Subject: Variance Permit Application No VP100594; 4087 Brink Place
Attachments: September 14, 2021.pdf; Subject lots.pdf; Subject development.pdf

Re: Development Variance Permit Application No. VP100594 - to decrease BOTH side and rear setbacks from 6.0 m to 3.0 m on 12 of 33 lots

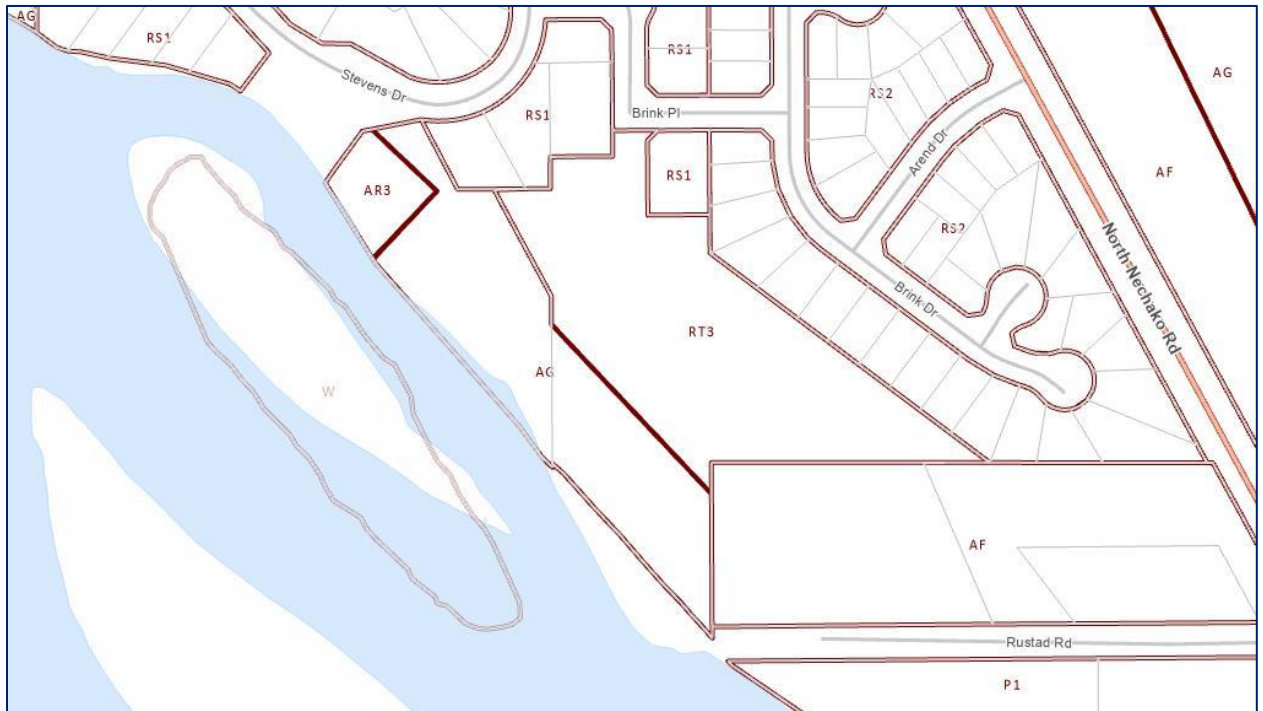
1. The nearby subdivision with RS2 zoning has a side yard setback of 1.2 meters or 3.94 feet, however they have a reasonable backyard with a minimum of 6 meters or 19.69 feet. The variance application asks for BOTH side and rear yards to have a 3 meter or 9.84 foot setback. The subject lots are actually adjacent to the RS1, AG and AF zonings listed above and are not next to the RS2 used in comparison.

2. "The proposed strata development is consistent with the form and character of surrounding RS2 (height, scale and form)." Again, RS2 does not surround the proposed development; and further there is no information provided to us regarding the height, scale and form of the proposed development to know that it is consistent.

3. "The proposed variance to Strata Lots 8-13 is from the internal AG zone boundary and does not impact adjacent parcels." It does impact the sensitive nature of the steep bank where a great number of the established trees were removed. The AG zoning is in place to protect the environment. A map showing the riparian setback in relation to the property lines and proposed dwellings would be helpful.

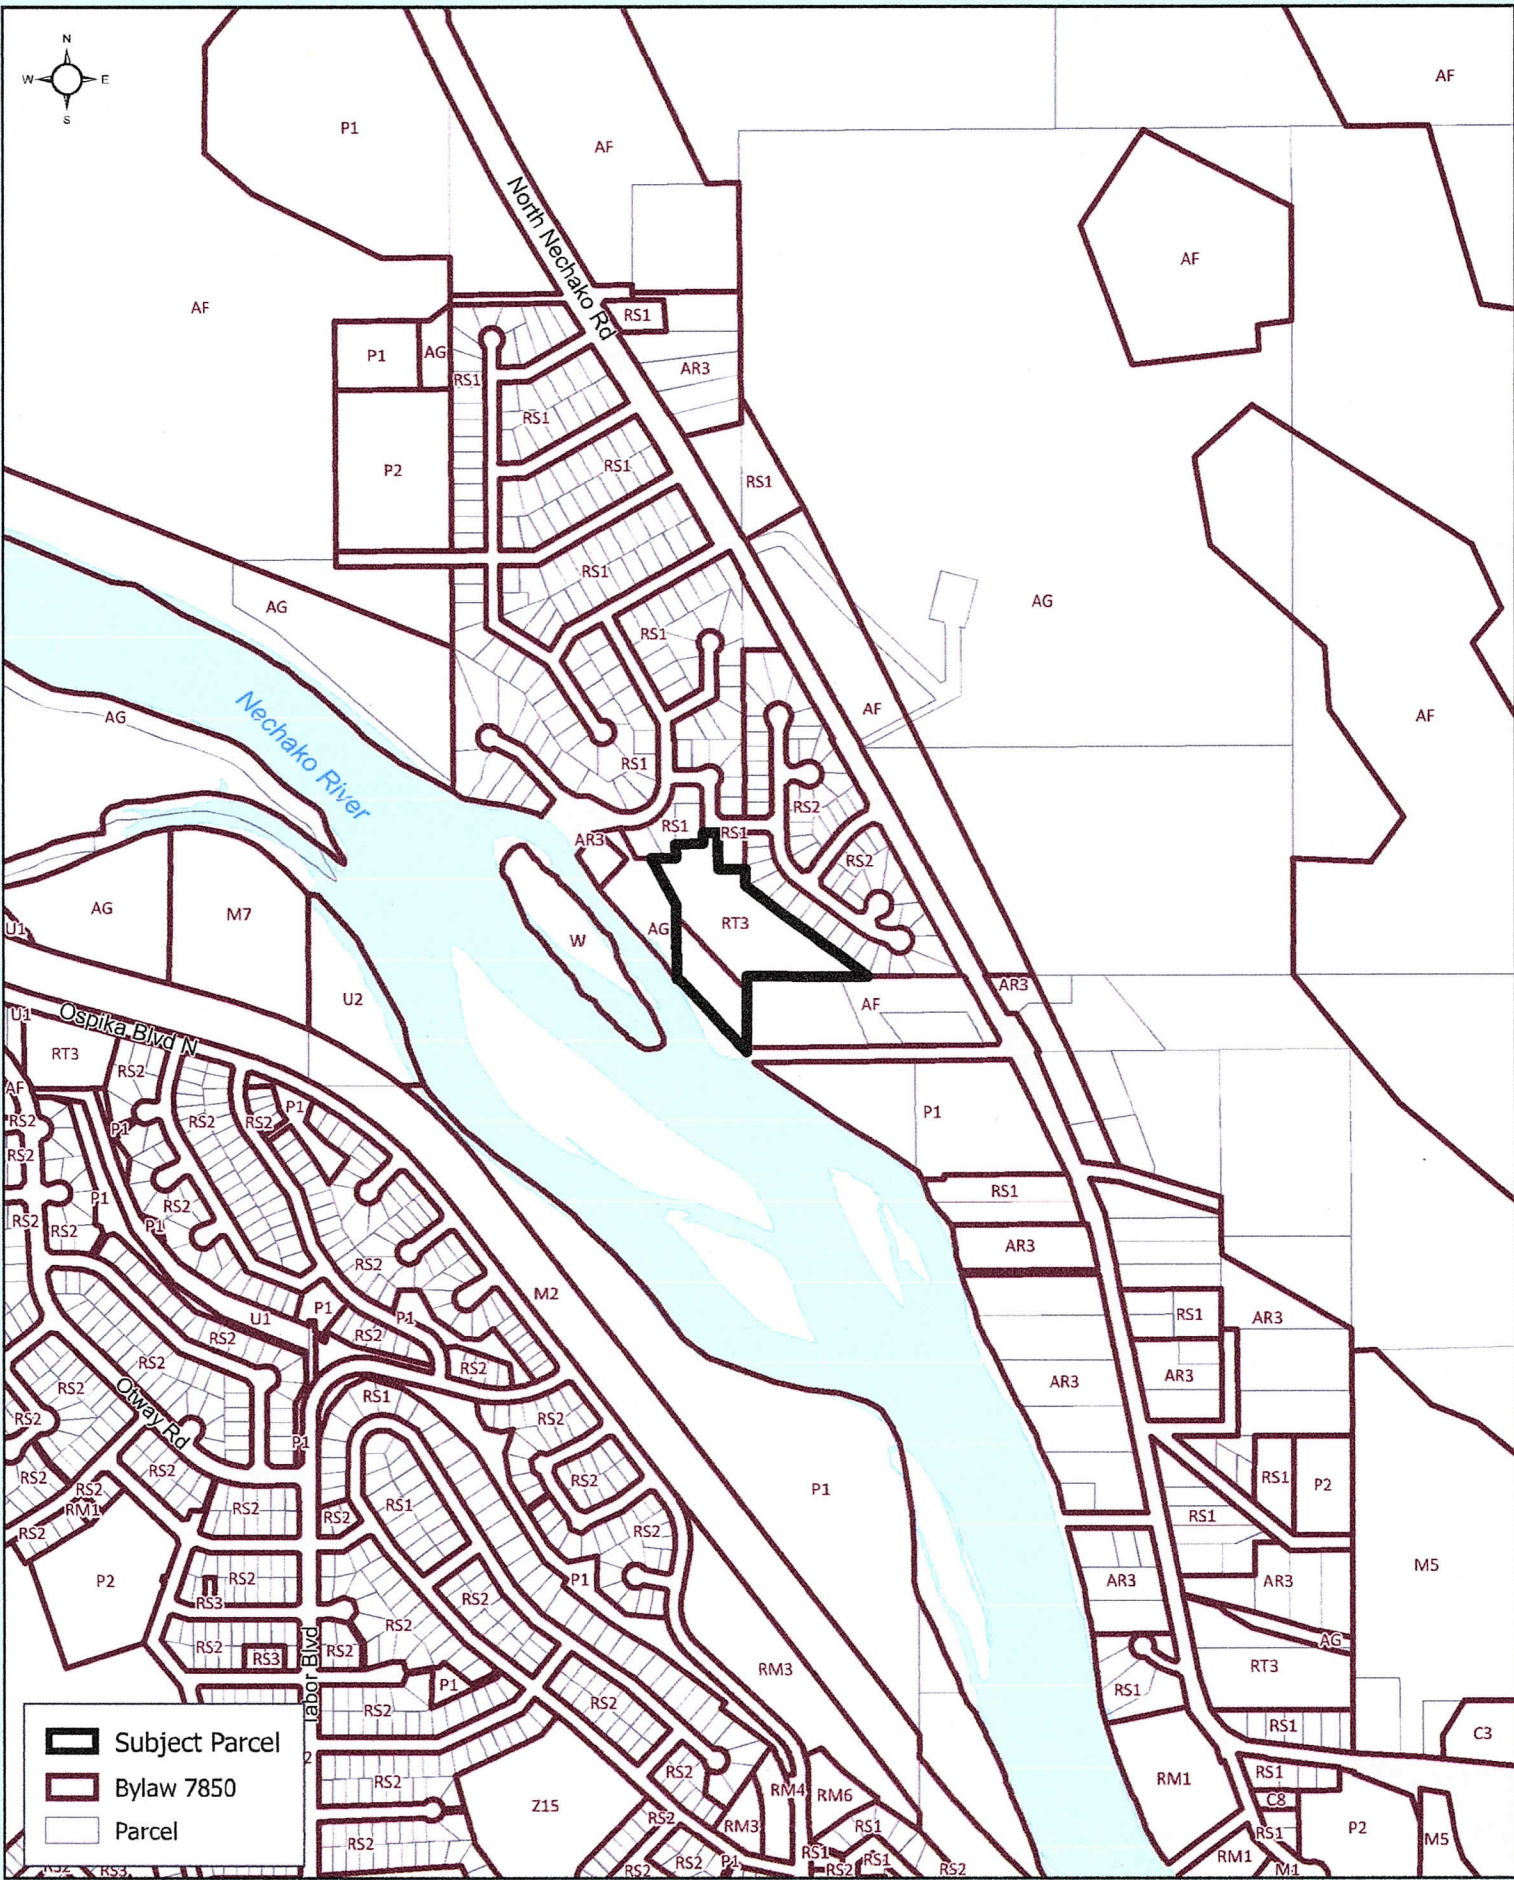
- 4 "Stata Lots 3 and 8-13 are adjacent to southern portion of the subject property, near the bank adjacent to the river thereby not adjacent to residential parcels." Lots 2 and 3 are adjoining and directly impact these neighbours by the proposed reduced setbacks of BOTH the side and back. They are already negatively affected by the higher street elevation created by the developer. Lot 3 is located at the highest elevation above the retaining wall and access going down to the river level. The top of the bank has been vulnerable to considerable erosion in recent years. Also, there are some established trees at the top of the bank that may be affected.
